Re: Site Observation (2nd)
North Valley Public Library
208 Main St.
Stevensville, Montana 59870

On Wednesday, January 4, 2017, a representative from Eclipse Engineering made a site visit to the above stated address. The purpose of the visit was to investigate the condition of the roof framing after an issue with a roof beam (excessive deflection) was found during renovation.

PARTIAL FRMG. PLAN - NOT TO SCALE

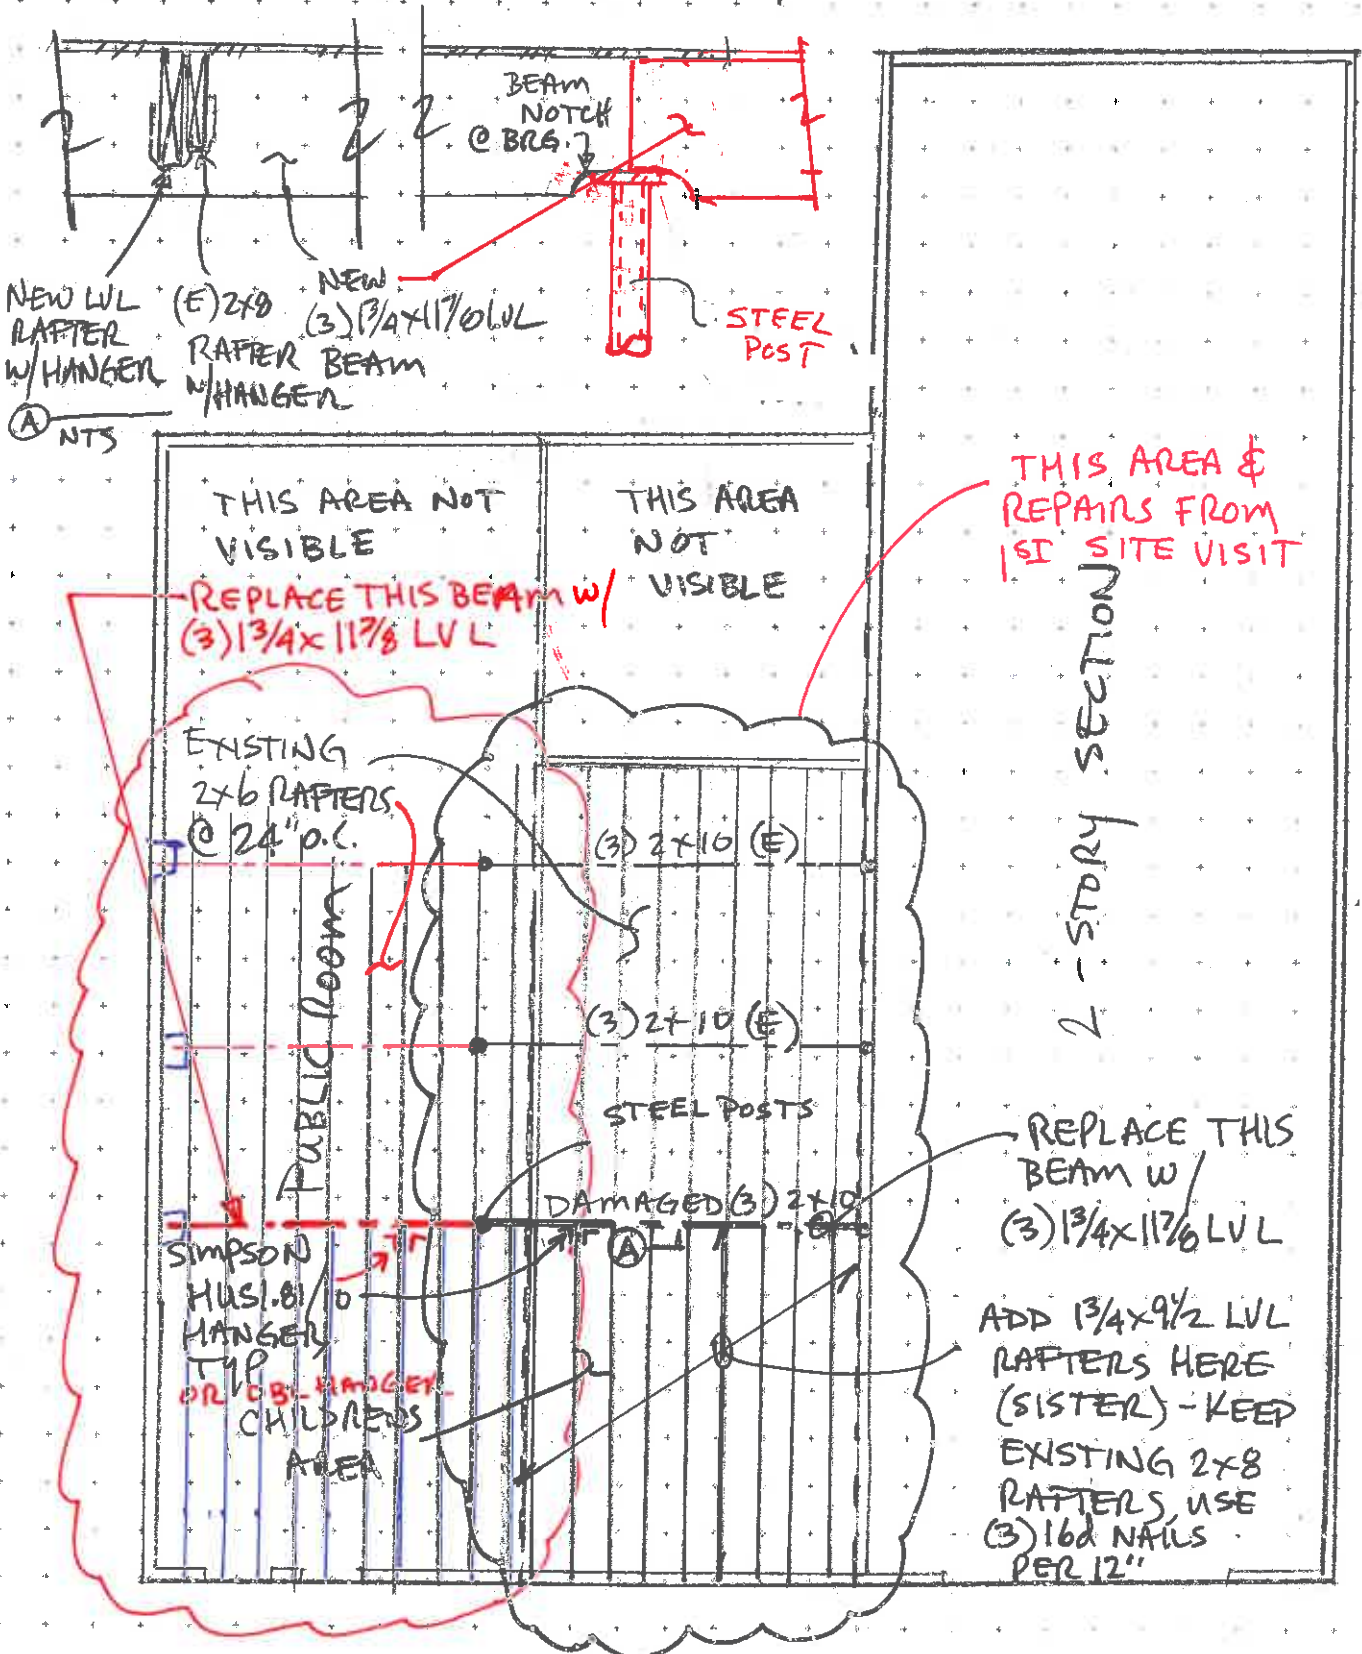
The 19 ft. rafter span is too long for 2x8's at 24" on center. Add (sister) 1 ¾"x 9 1/2" LVL rafters to each 2x8 rafter spanning 19 ft. Use appropriate Simpson hangers at the new beam. Nail existing rafter and new rafter with (3) 16d nails per 12".

Although the beam in question, (3) 2x10's, has not failed, the large deflection is a definite concern and it is recommended that it be replaced with a new (3) 1 ¾" x 11 7/8" LVL beam.

Attach all new and existing rafters to this beam with Simpson hangers. If required, the beam may be notched to match the bearing conditions of the existing (3) 2x10 beam, do not notch with a square cut, ref. detail A.
